Preliminary Consultation MONTGOMERY COUNTY HISTORIC PRESERVATION COMMISSION STAFF REPORT

Address: 7835 River Road, Bethesda Meeting Date: 8/14/2024

Magruder's Blacksmith Shop

PROPOSAL: Fenestration alterations.

Figure 4: The as-built drawing for the front door and a recent photo of it.

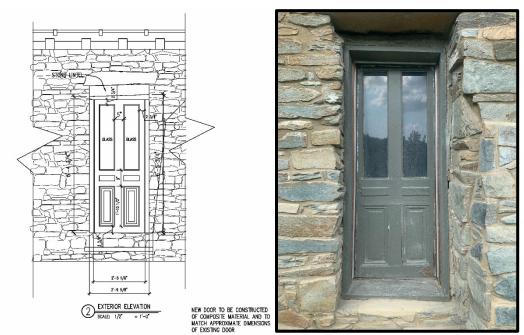
The existing door has wood panels at the bottom and rectangular Plexiglass lites at the top. The applicant proposes to replace with a composite door with glass lites similar in design to the existing door.

Staff finds the door material and designs incompatible to the historic building and do not meet either Chapter 24A-8(b)(2) or *Standards* #2. The proposed composite material is not appropriate for building, and staff recommends wood doors instead. Staff understands why the applicant sought to copy the design of the existing doors, both of which appear to have been longtime features of the building. But neither door design is compatible to the building, which was built by 1751. Now that both the existing doors have reached the end of their lifespan, the applicant has an opportunity to both suit his needs to secure the building and improve livability for future tenants while also finding doors that are compatible in character with the building's historical and architectural 18th century period of significance. Staff recommends the applicant instead propose matching wood board and batten or vertical plank doors, which were the predominant door design at the time of the building's construction. The replacement doors need not be true reproductions and may include modern features such as lites and hardware. Staff would be glad to provide the applicant with potential examples of compatible doors. This work would also qualify for the County's rehabilitation tax credit.

Figure 5: The as-built drawing for the back door and an existing photo of the door.

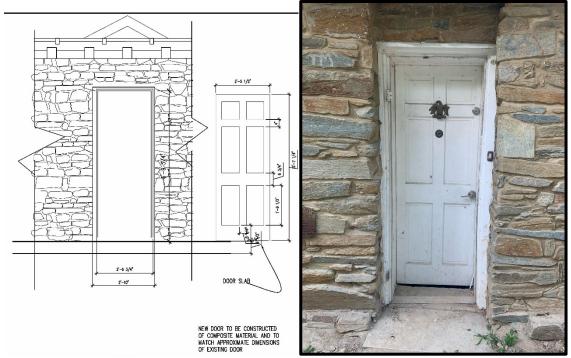
The applicant proposes to replace the paneled rear door with a composite paneled door. The applicant described the existing door as fiberglass.

Figure 6: The drawing for the 6/6 window on the front elevation and an recent photo of it.

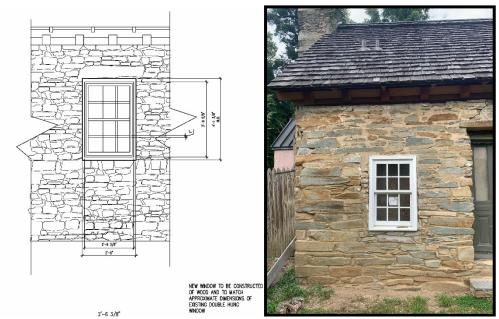
Staff supports the proposed replacement of the two 6/6 wood sash windows and six-lite wood hopper window. In accordance with Chapter 24A-8(b)(1), the replacement windows will not substantially alter the exterior features of the historic site, and per Chapter 24A-8(b)(2) the proposal is compatible in character with the historic site. In accordance with the applicable *Standards*, the historic character of the property will be retained and preserved by the installation of the replacement windows; the alteration will not destroy historic materials that characterize the property; and the essential form and integrity of the historic property and its environment will be unimpaired if they are removed in the future.
